Staff Report

Infill Housing Design Review Committee

File Number: 11-A-21-IH

Location: 438 Hiawasse Ave. **Parcel ID** 81 B C 008
Zoning: RN-2 (Single-Family Residential Neighborhood)
District: Oakwood/Lincoln Park Infill Housing Overlay District

SITE PLAN

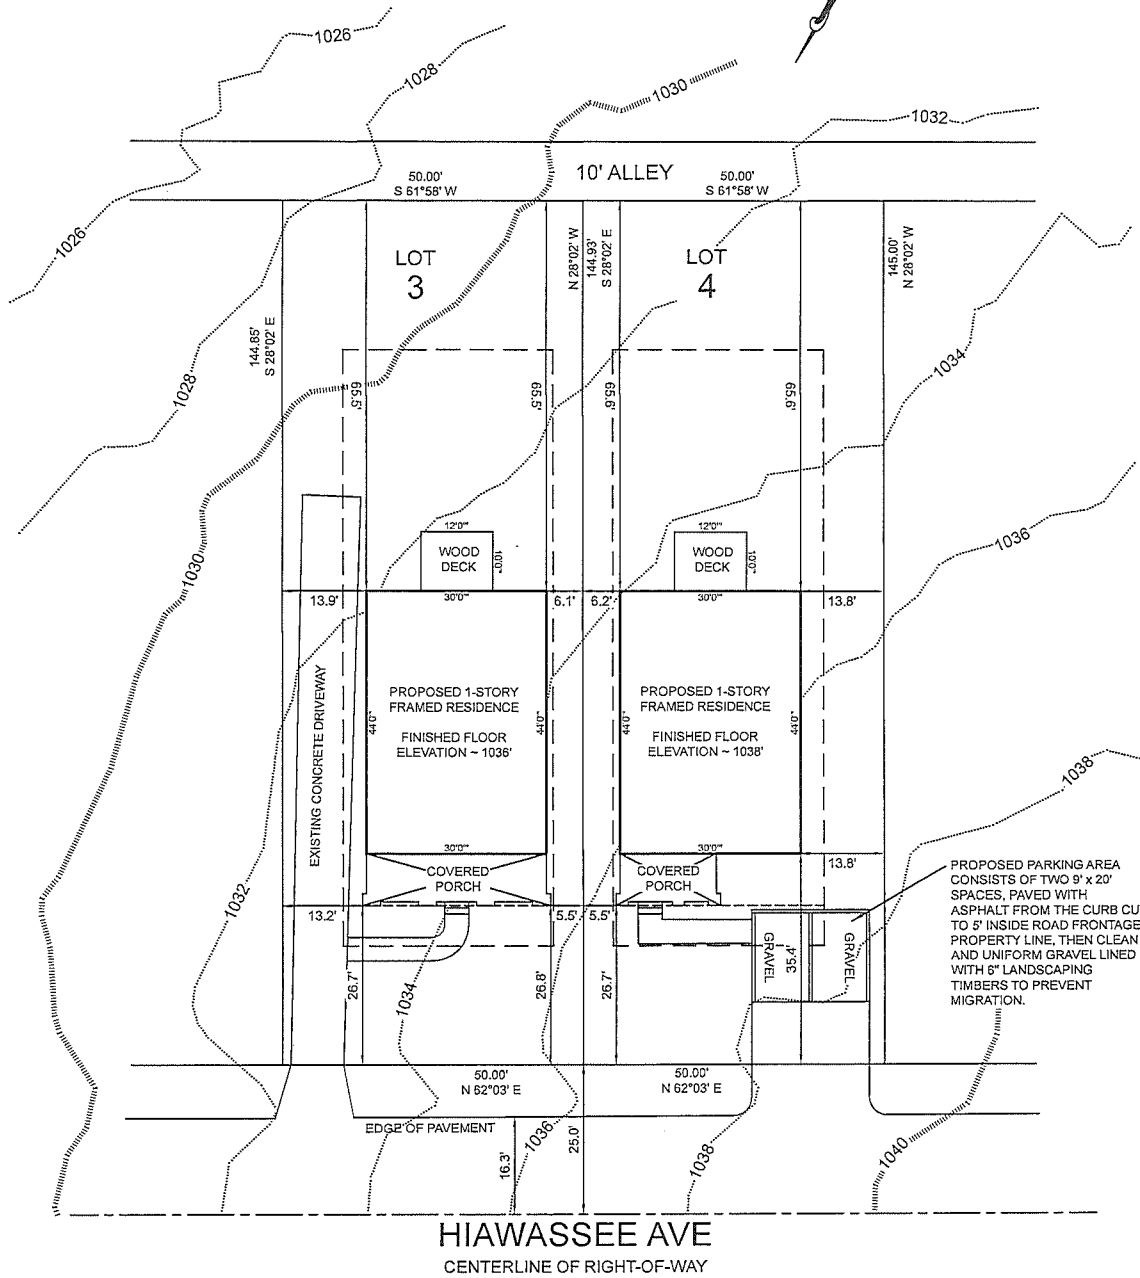
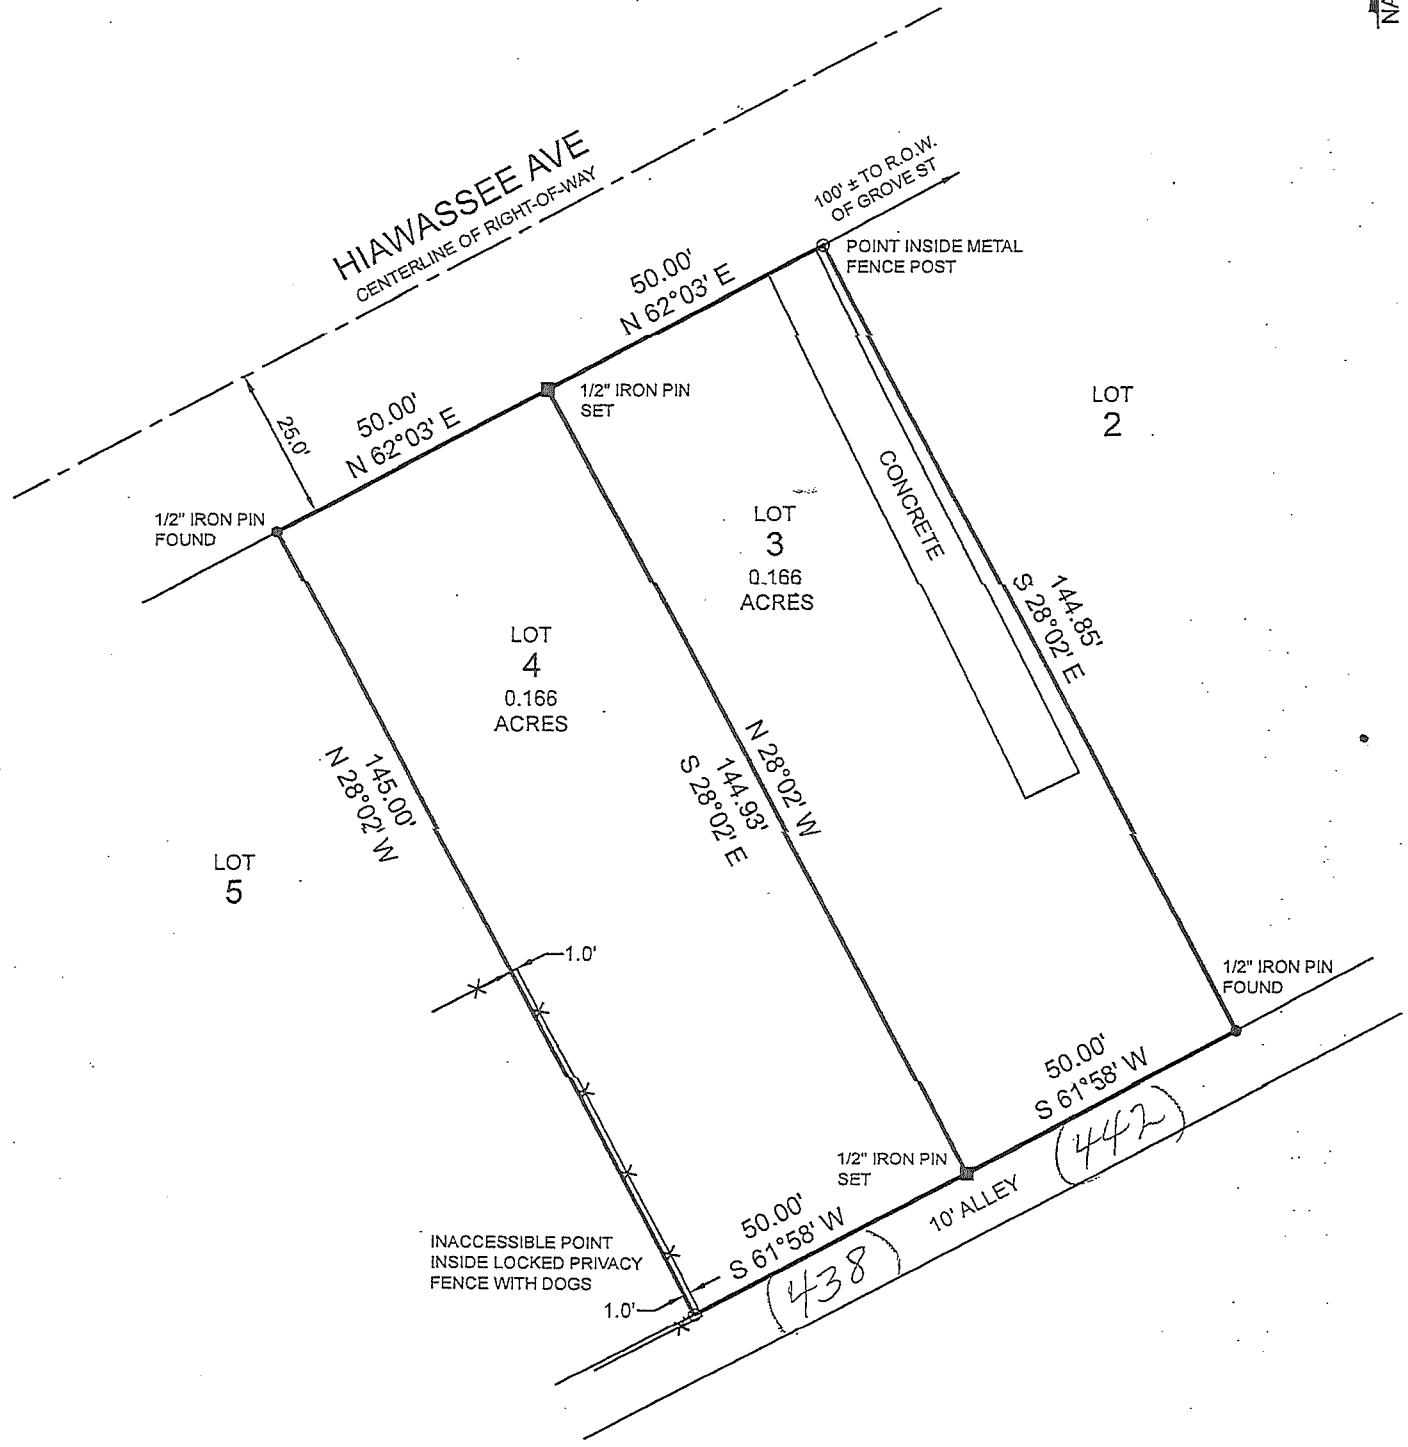
from the front property line. The average front setback of the block is 26.2'. Along with the adjacent new house at 442 Hiawasse Ave, the new house will maintain consistent front yard space with the block. The final site plan should incorporate a walkway from the front porch to the street.

3. To meet Infill Housing guidelines and City Engineering standards, the proposed parking should extend off the alley and be located to the rear of the property instead of in the front yard. City Engineering has also noted the necessity of raising the house's finished floor elevation to provide positive drainage and improve the drainage swale at the street.

9. The final site plan should incorporate one native or naturalized shade tree in the front and rear yards.

- 1) Incorporate a walkway from the front porch to the sidewalk or street;
- 2) Parking to meet Infill Housing guidelines and City Engineering standards, and be located at the rear of the property off the alley;
- 3) Incorporate brick-clad bases on the porch columns;
- 4) Use consistent window designs on all elevations and omit non-operable shutters;
- 5) Use vinyl siding with an overlap instead of Dutch lap or flush panel siding;
- 6) Incorporate one native or naturalized shade tree in front and rear yards.

FRONT ELEVATION
SCALE: 1/4" = 1'-0"

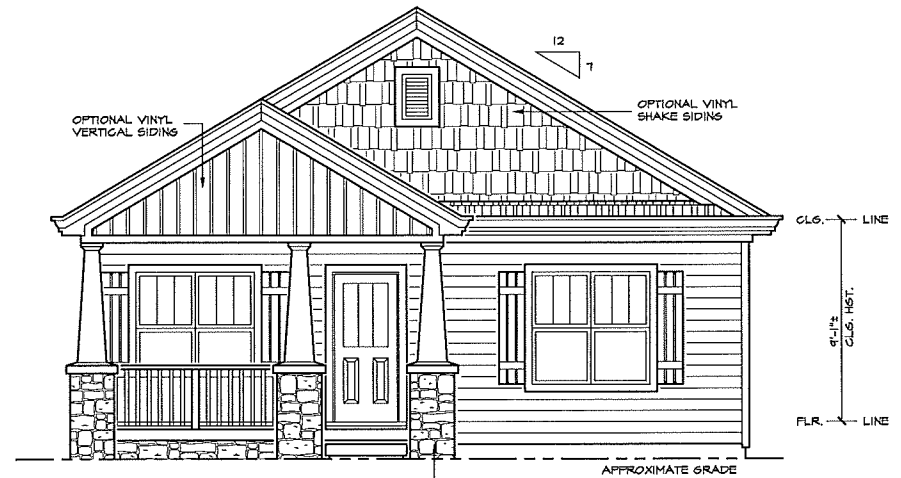
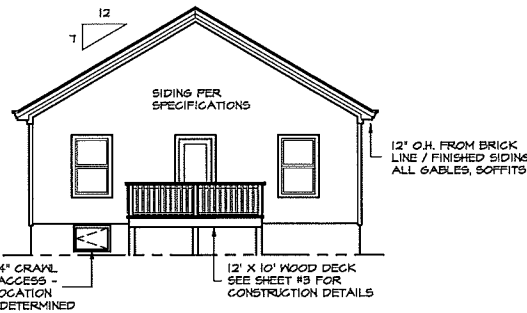
5. The proposed front-gable roof porch, including the Craftsman-style detailing, meets the design guidelines for size and placement. Infill Housing design guidelines discourage the use of stone veneer; brick should be used as cladding for column piers instead.

6. The proposed window and doors are compatible with historic elements on the block. There is sufficient transparency on side elevations. The applicant should select consistent window patterns on all elevations (either all 1/1s or 3/1s) and omit non-operable shutters.

8. Overall materials are appropriate within the design guidelines. The vinyl siding should be lap siding with an overlap instead of Dutch lap or flush panel siding.
